Title		
VZ300 ASIC Retro		
Size	Document Number	Rev
A4	GA004	1.2
Date:	Wednesday, October 02, 2019	Sheet 1 of 1

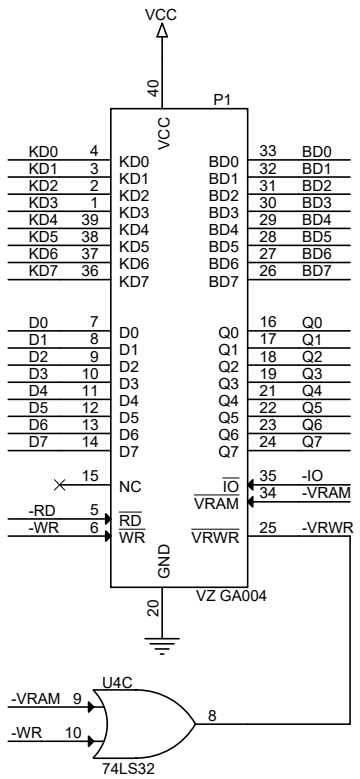
date	rev	changes
191001	1.2	Fixed bug, 74LS244 in/out were swapped.
